CUMNOR PARISH COUNCIL

BOTLEY WEST SOLAR FARM (BWSF) REF: EN010147

In response to your 11th June 2026 invitation to respond to submissions made to your 28th April 2026 Request For Information, Cumnor Parish Council (CPC) as an Interested Party (IP) is today submitting two documents to you by email:

This document is the 1st of the two. Each question addressed comprises an assessment and summary sections.

Image 1 centred on w3w location ///hits.logic.obey

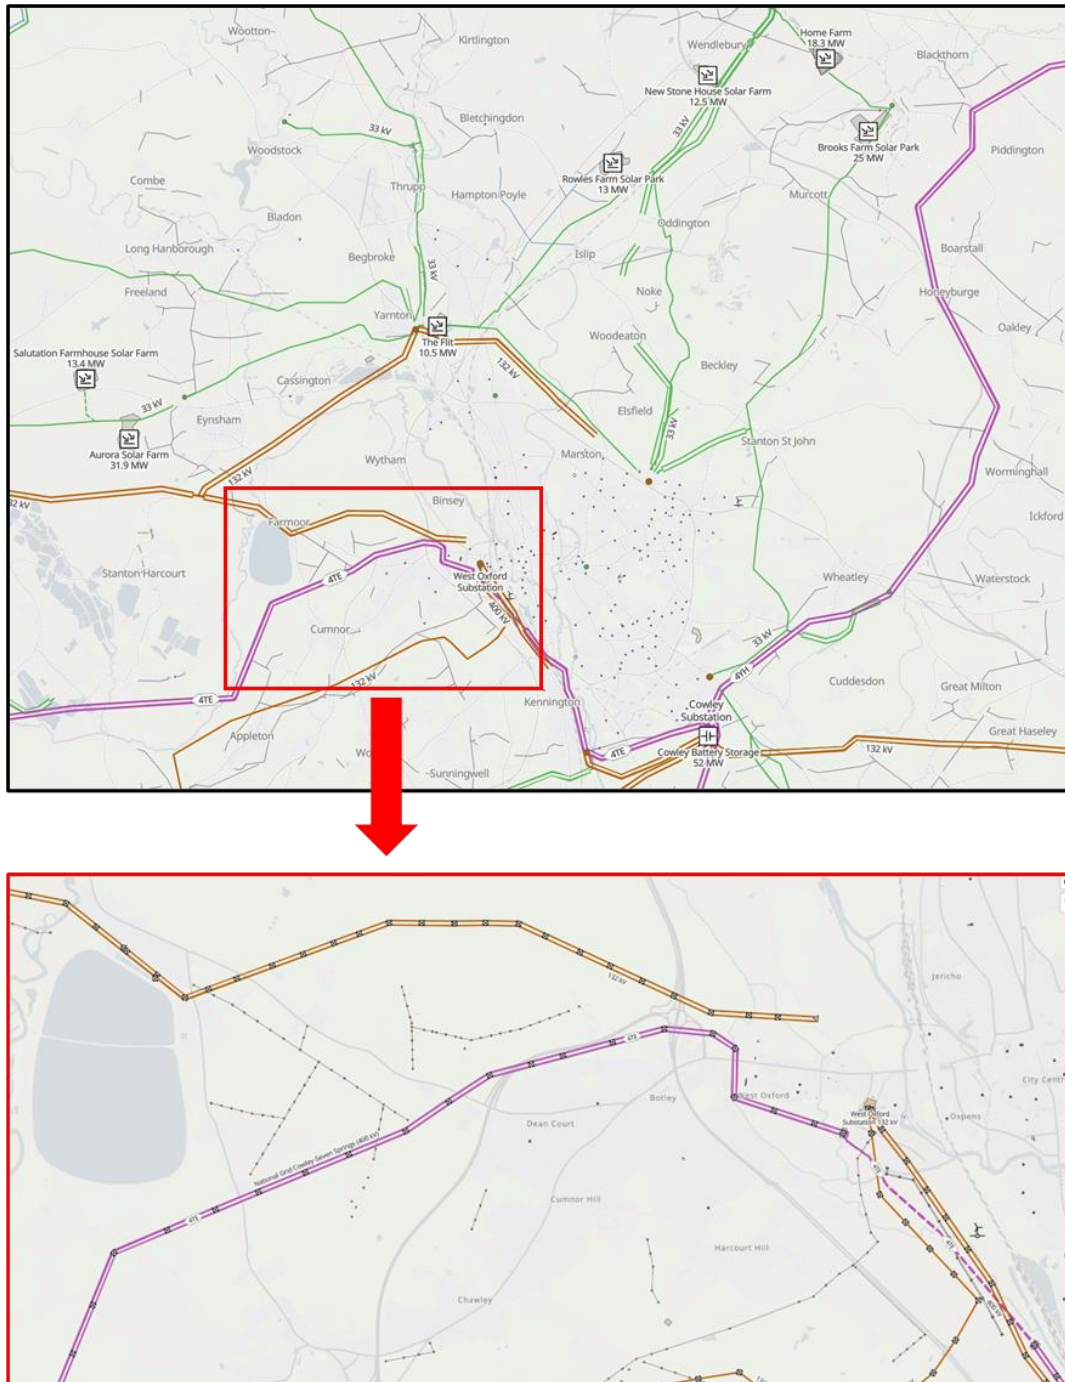
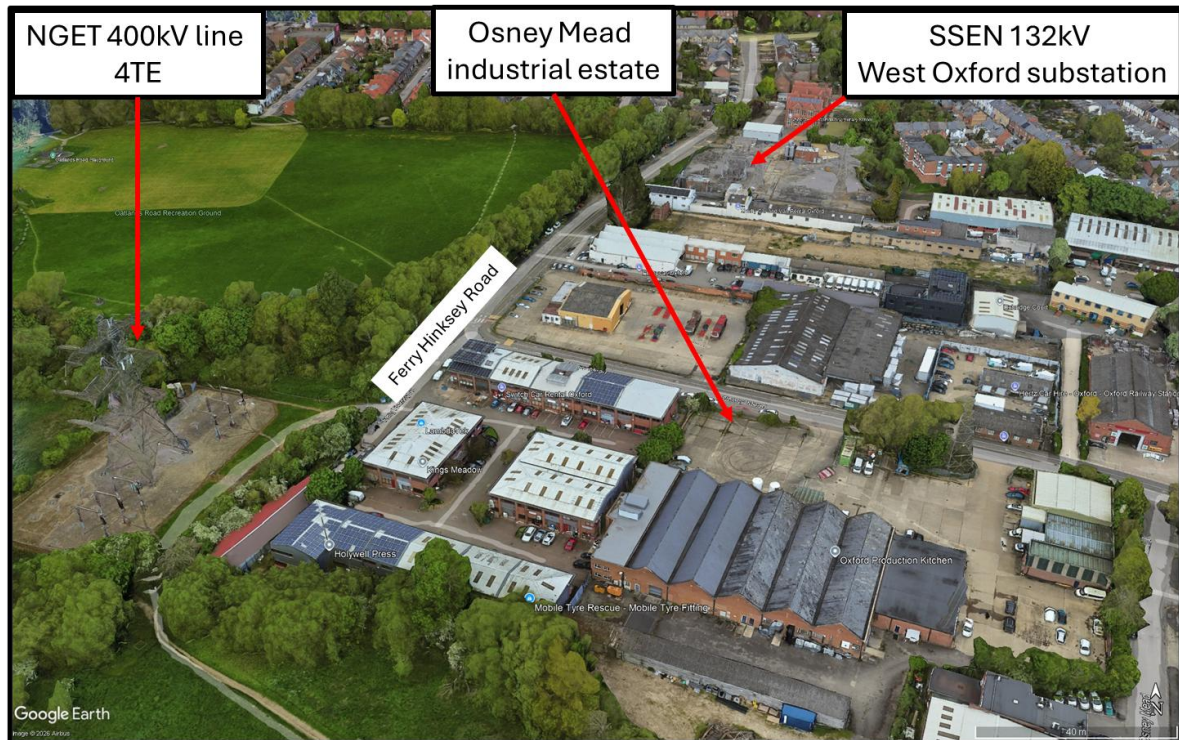
This proposal at only 6% the size of Botley West (49MWe to Botley West's 840MWe) and so, presumably only requiring c. 6% of the capital and generating c 6% of the revenue, has successfully applied for planning permission to Oxford City Council for this very cable route

to the SSEN substation on Ferry Hinksey Road (**Oxford City Council planning application 23/02816/FUL granted on 27th April 2026**).

This substation is only 50m from NGET's Cowley - Seven Springs 4TE 400kV line, both situated on an underutilised brown field site (see Map 3 and Image 1 below).

The NGET 400kV line '4TE', the adjacent SSSEN 132kV substation, Ferry Hinksey road and the Osney Mead Industrial Estate.

Image 6
From para 8.5 of **REP7-077**

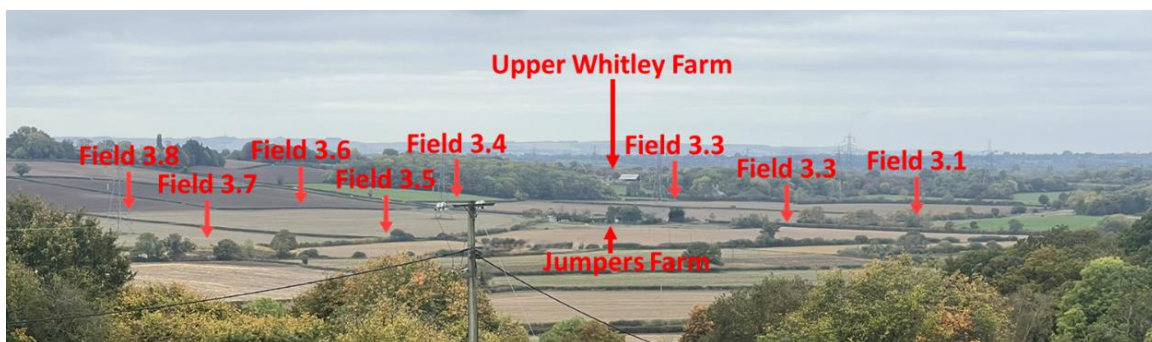
The Applicant's **page 66 in C1-087** also continues to ignore the Hill End Outdoor Education Centre as a representative viewpoint (it not even appearing on their submitted maps), something Cumnor Parish Council provided in **para 8.5 of its REP7-077** and which the ExA saw for themselves when they visited Hill End in their ASI in October 2025.

Map 5
page 156 of **C1-087**

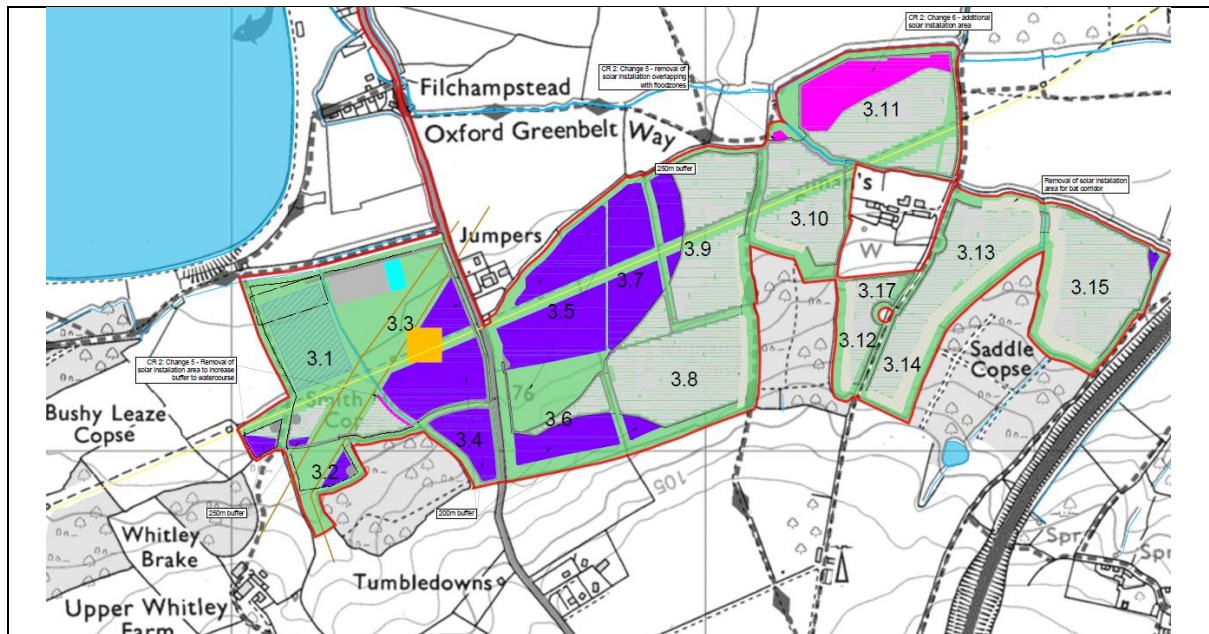
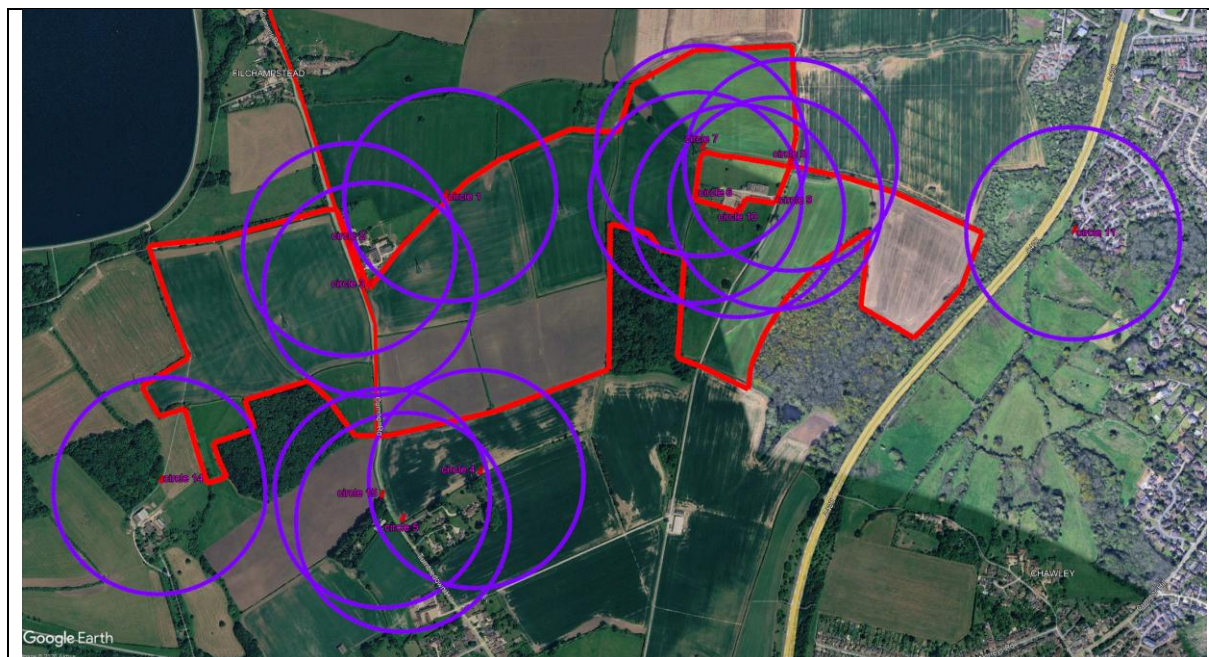
As but one example the map on page 156 of **C1-087** purports to show the southern site with 'indicative 250m buffer' shown as . It doesn't.

Compare the Applicant's map (Map 5 below):

with a map produced by this Interested party that depicts the reality for 250m buffers (Map 6 below):

Map 13

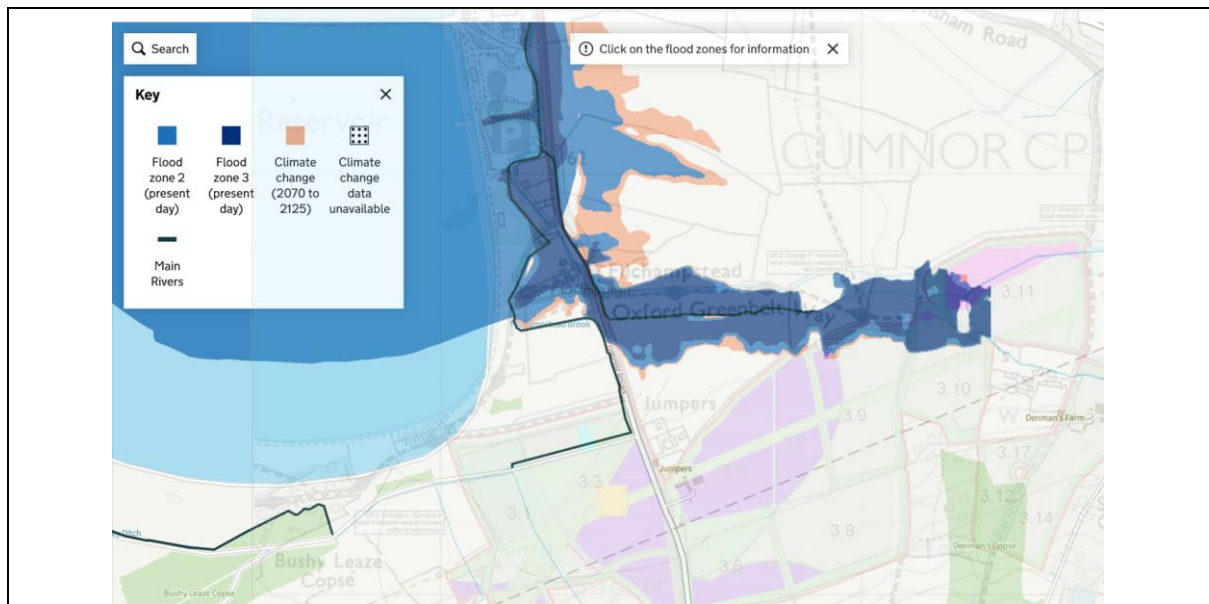
It would also be untrue if the EA considers the power converter stations (PCS) housing the inverters and medium-voltage 1kV/33kV transformers to be '*sensitive infrastructure*' since the Applicant proposes to place them within the solar PV panel fields. (Map 13 below)
